Hot Springs Village POA
Cedar Creek WWTP Improvements
Project No. 24022

**ADDENDUM NO. 4 TO THE
CONTRACT DOCUMENTS**

**HOT SPRINGS VILLAGE POA, HOT SPRINGS VILLAGE, AR
CEDAR CREEK WWTP IMPROVEMENTS**

JOB NO:
24022
SHEET NO:
195M302

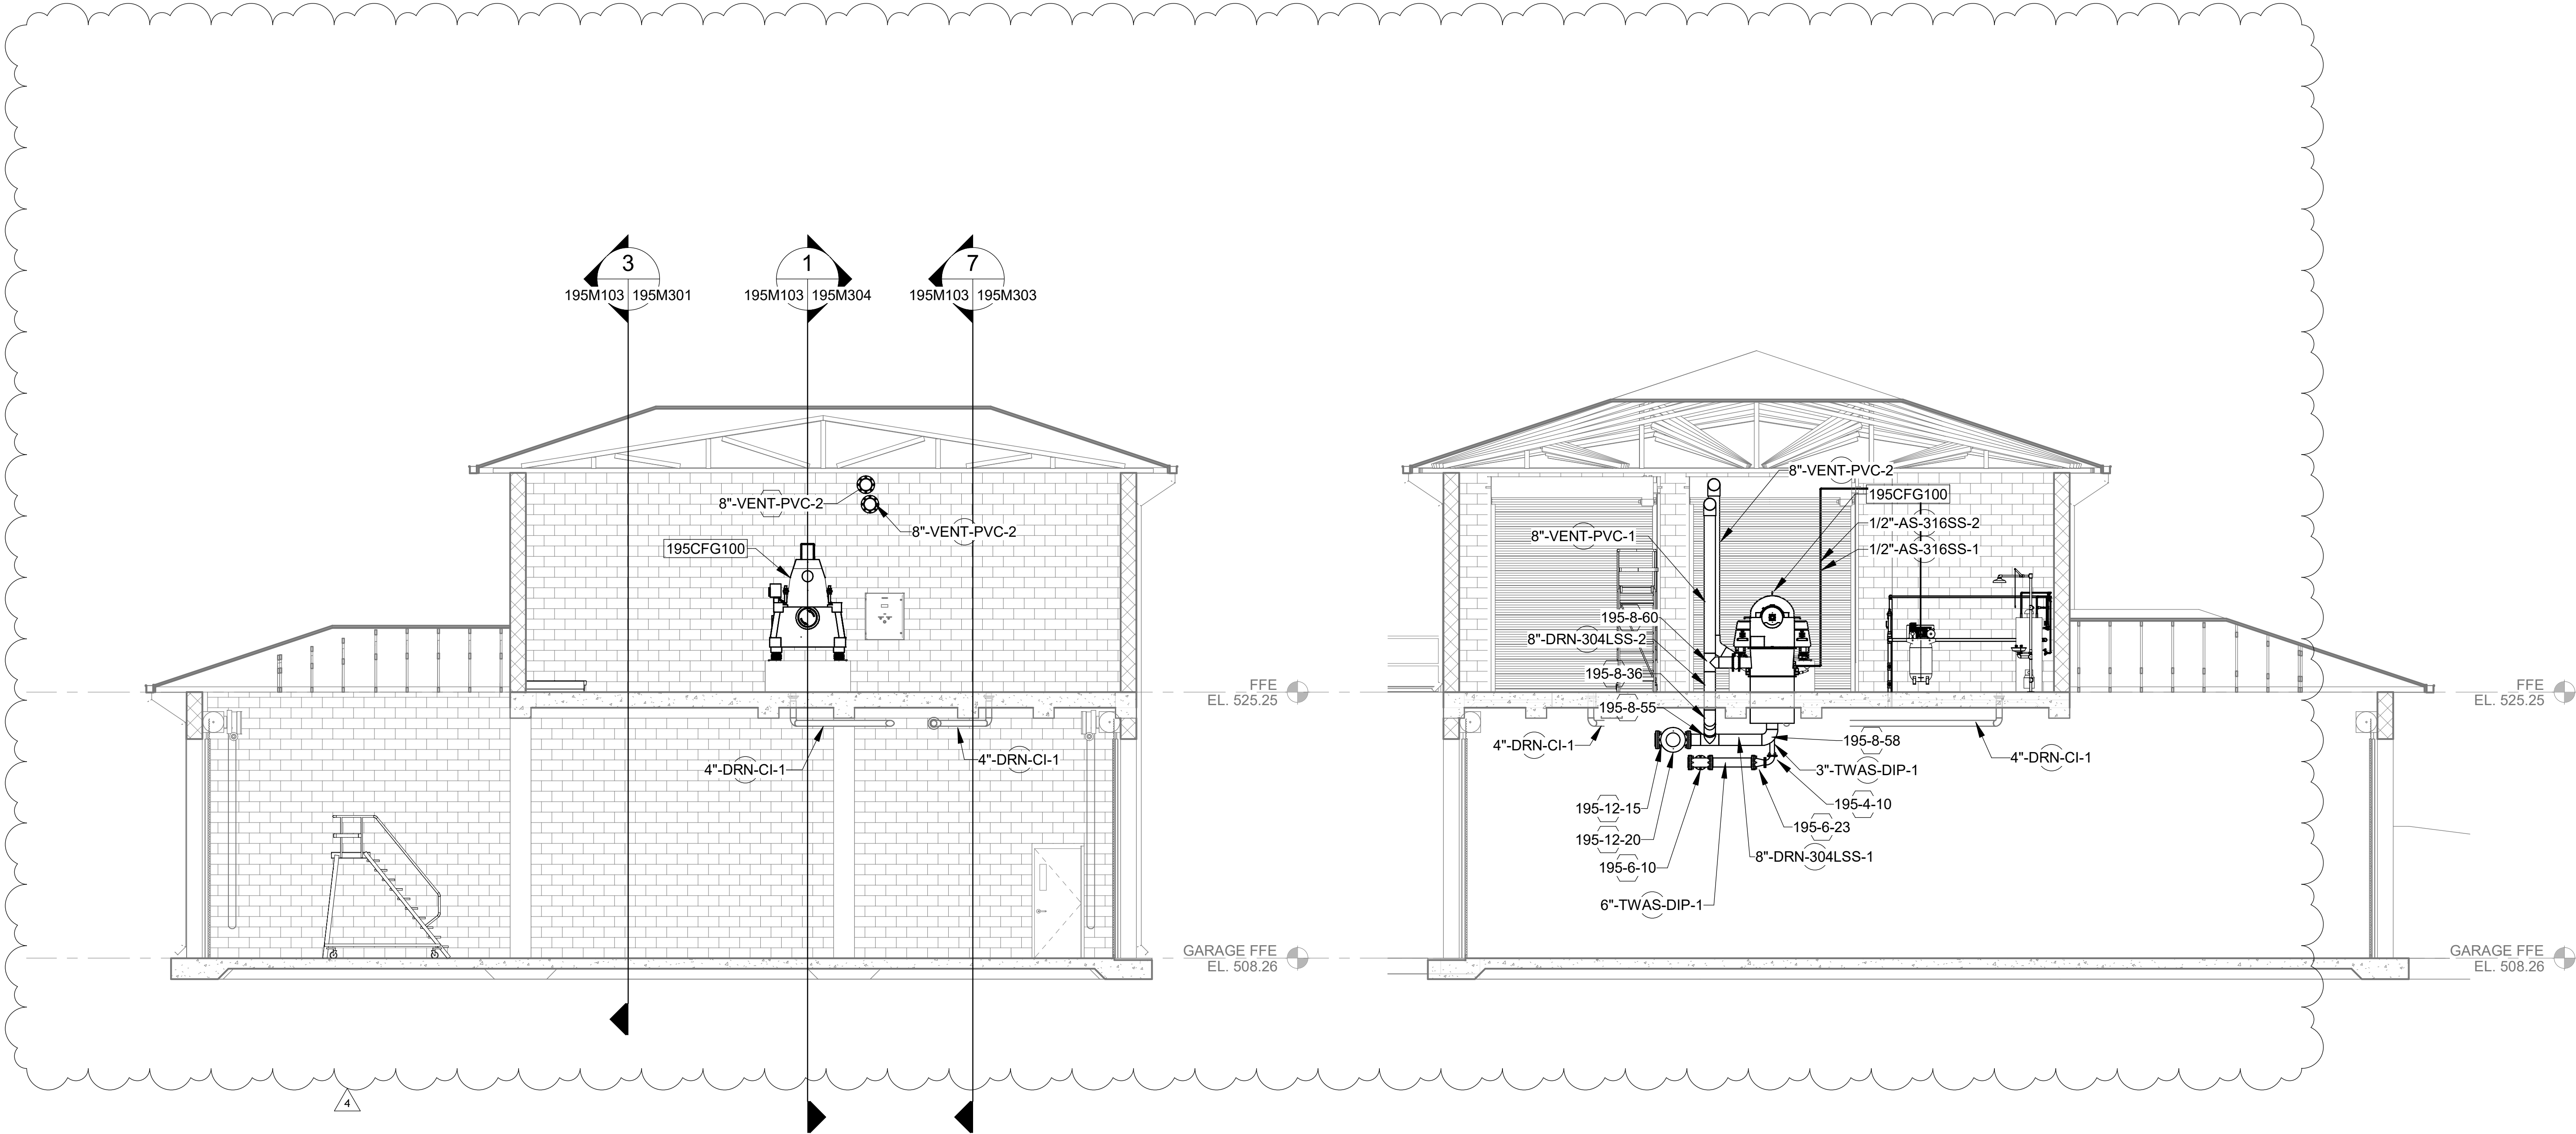
REV. NO.	DATE	DRWN	CHKD	REMARKS
4	5/29/26	MAB	BNW	REVISED PIPING CALLOUTS AND MATERIAL

195M303

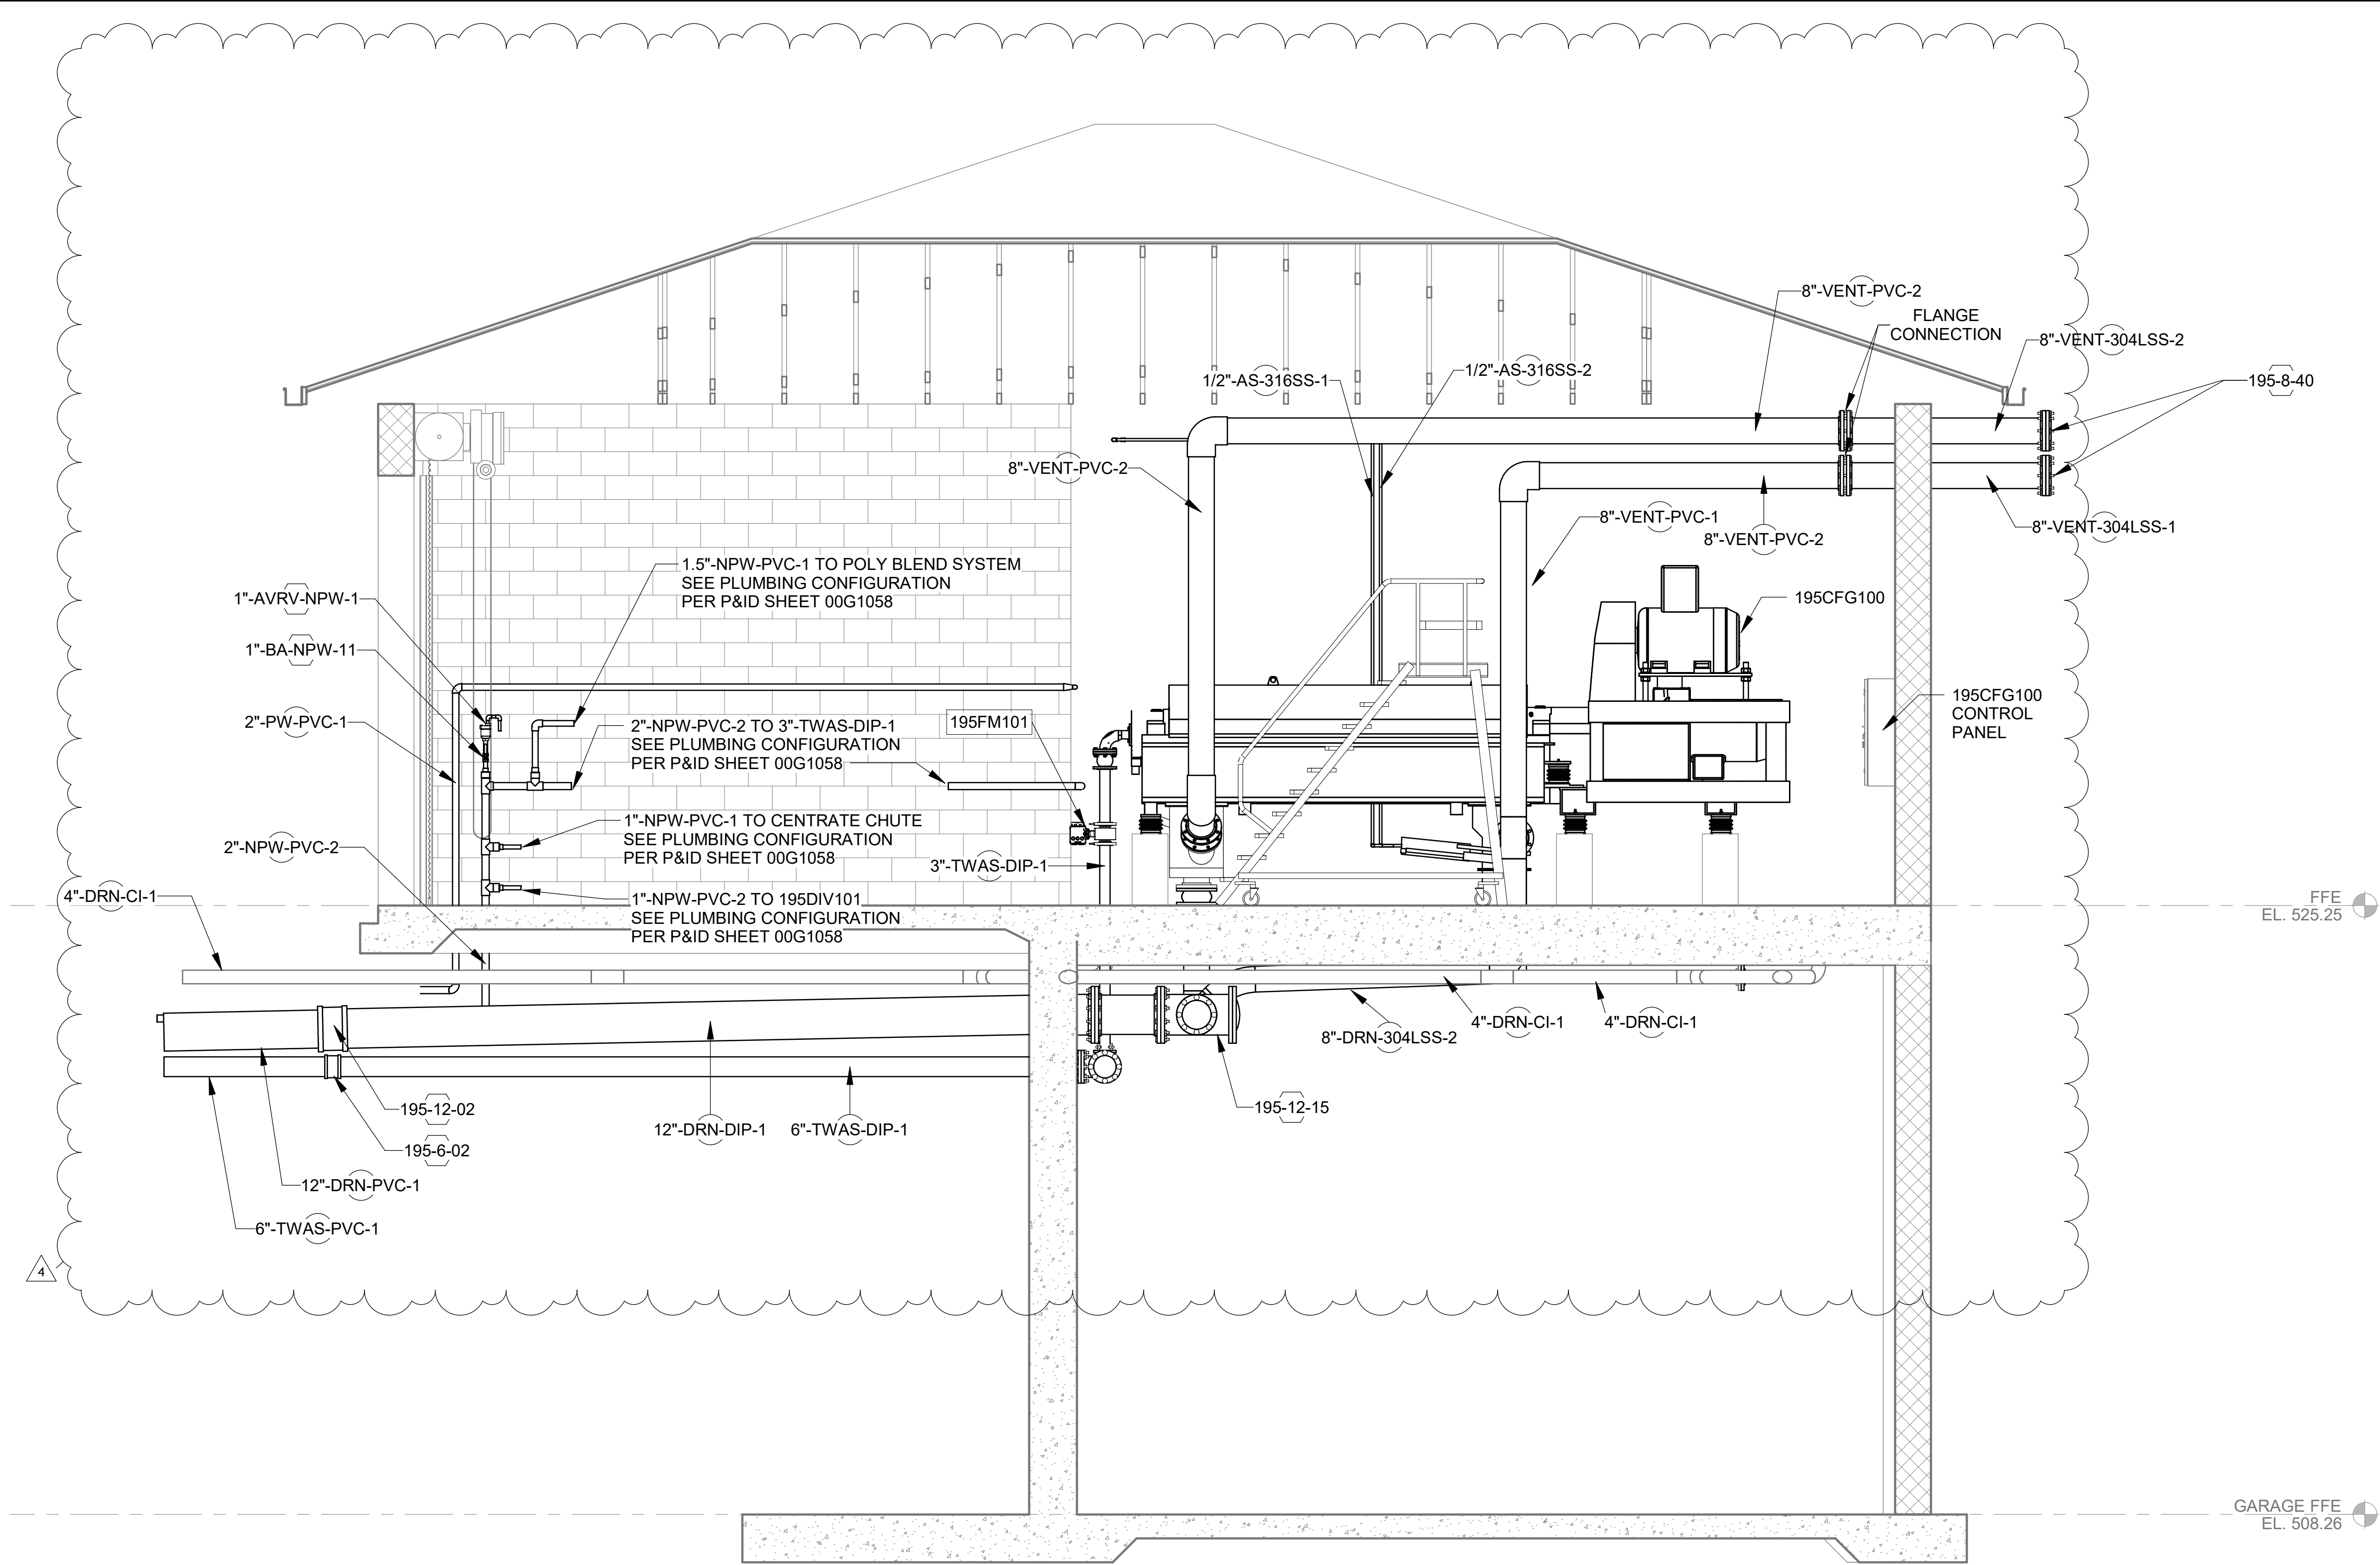
REV. NO.	DATE	DRWN	CHKD	REMARKS
4	5/29/26	MAB	BNW	REVISED PIPING CALLOUTS AND MATERIAL

JOB NO:
24022
SHEET NO:
195M304

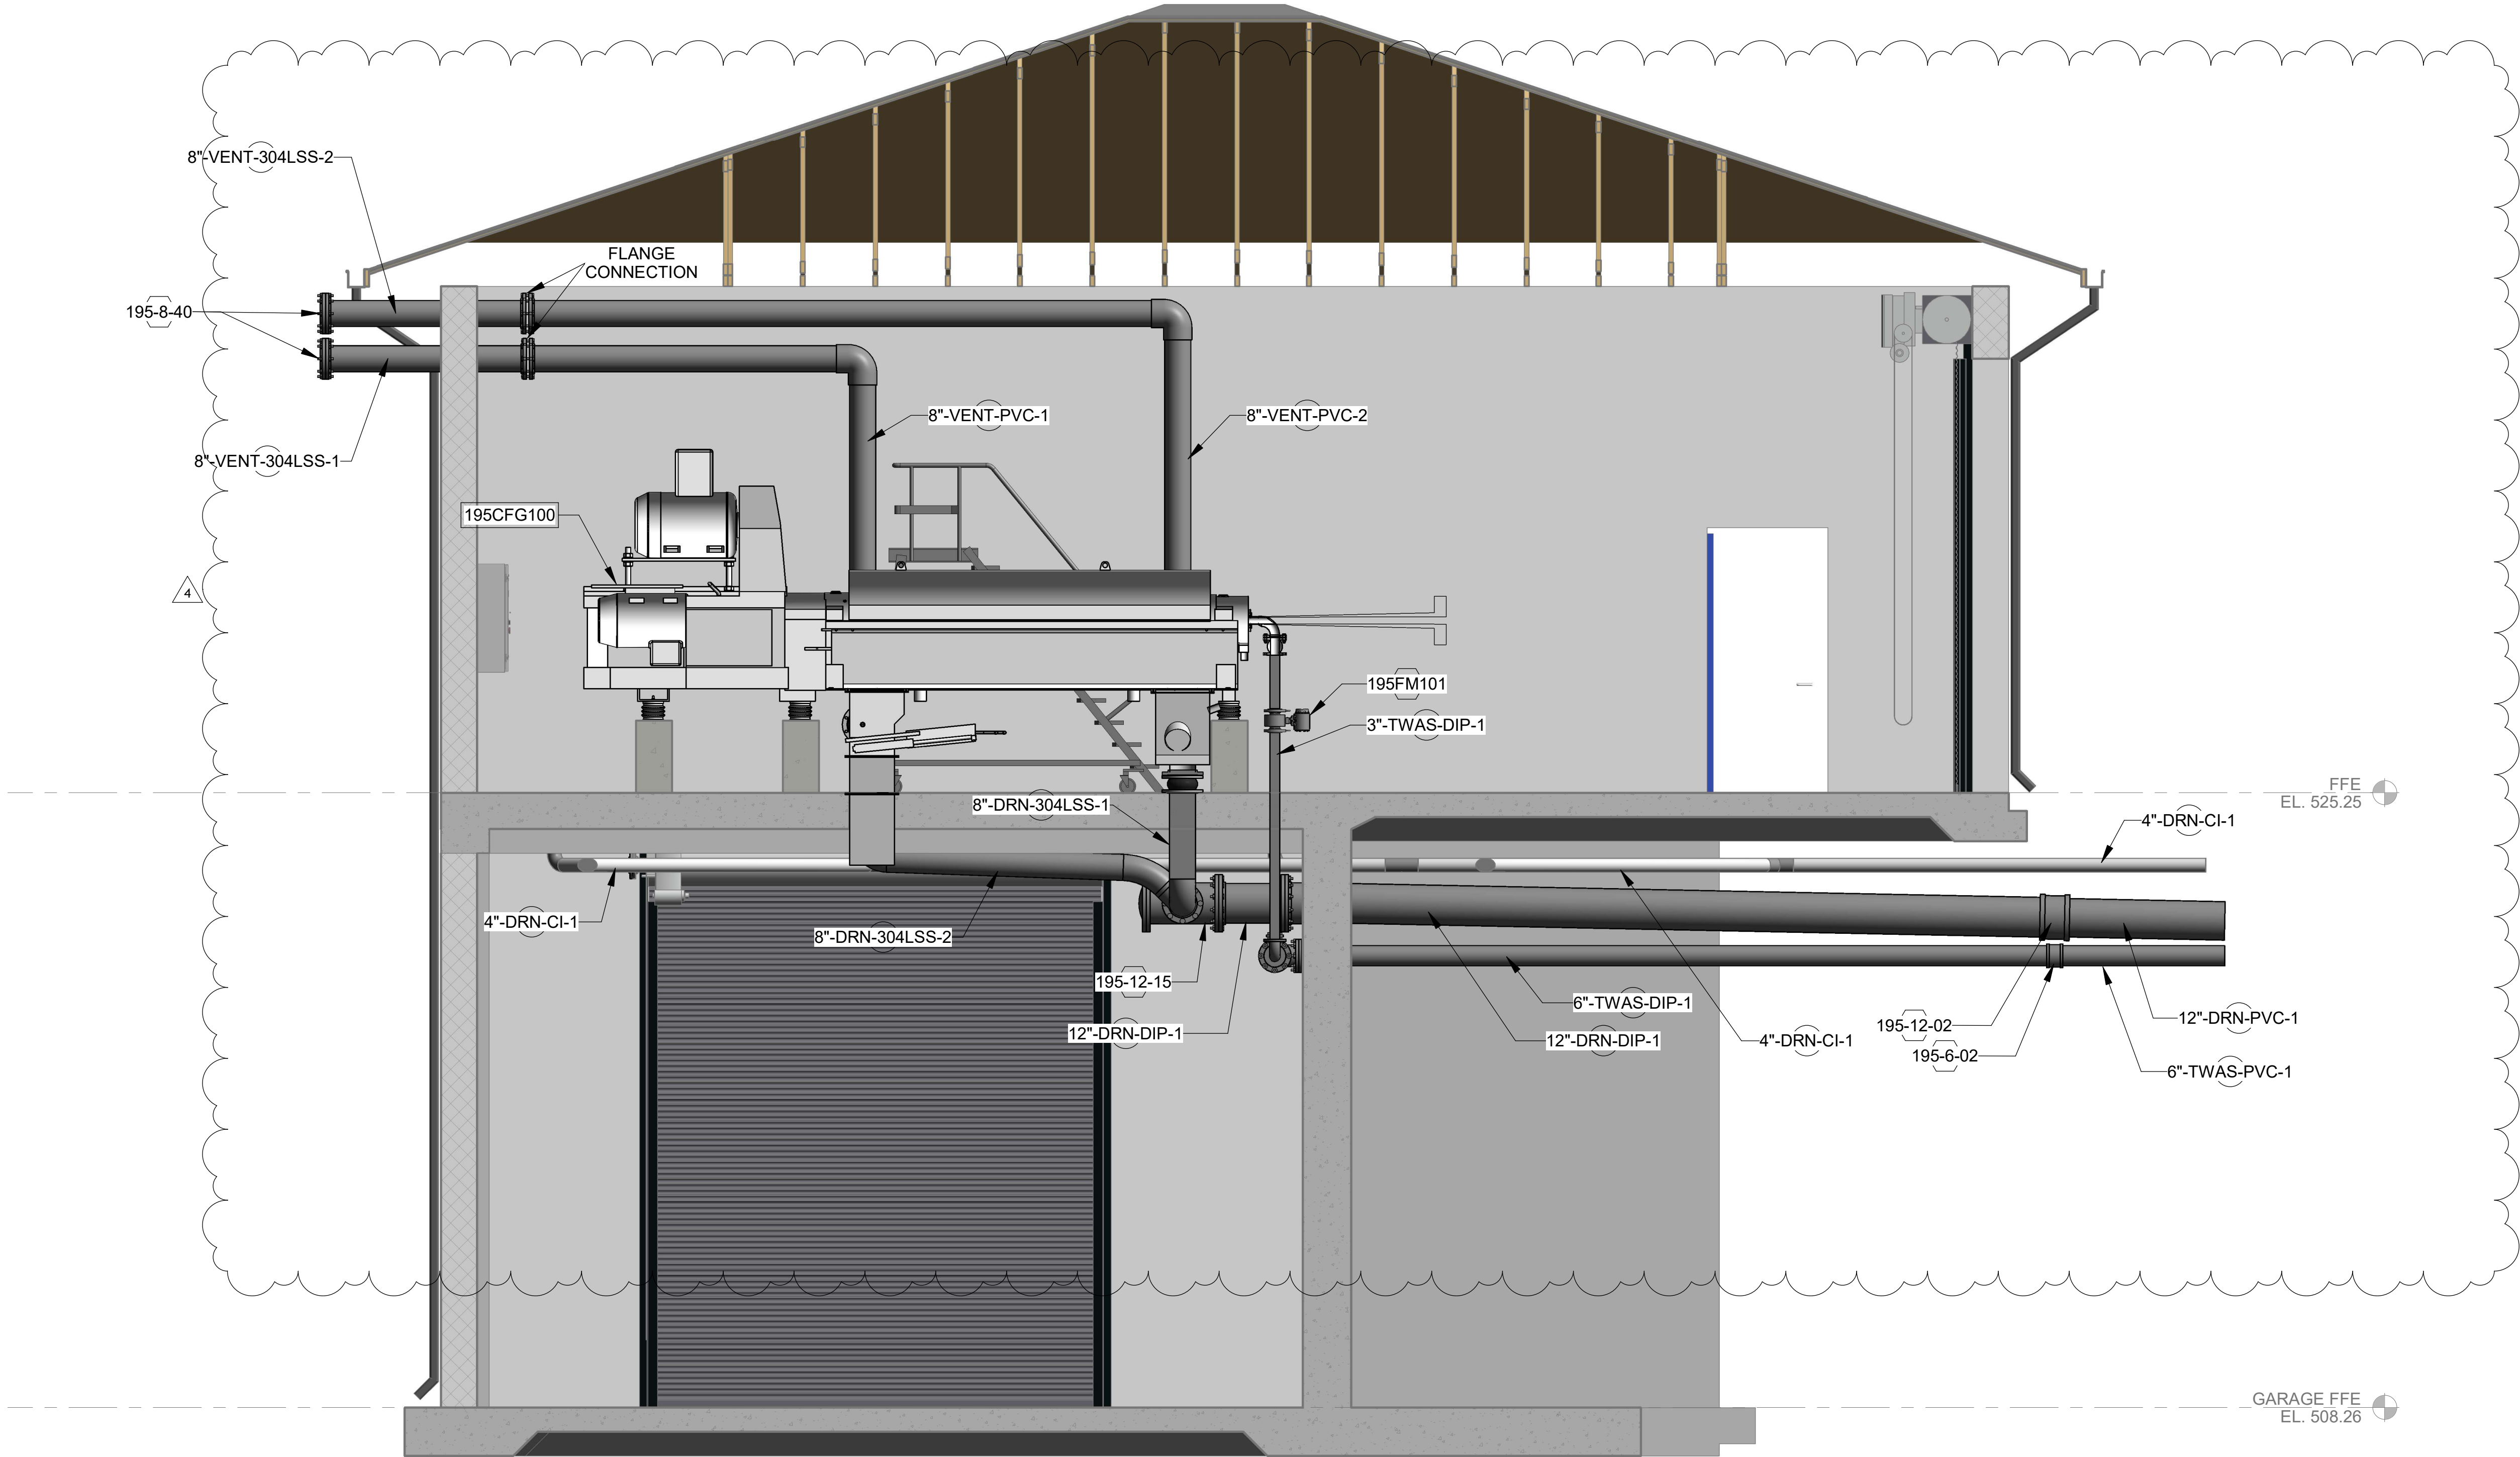
REV. NO.	DATE	DRWN	CHKD	REMARKS
4	5/29/26	MAB	BNW	REVISED PIPING CALLOUTS AND MATERIAL
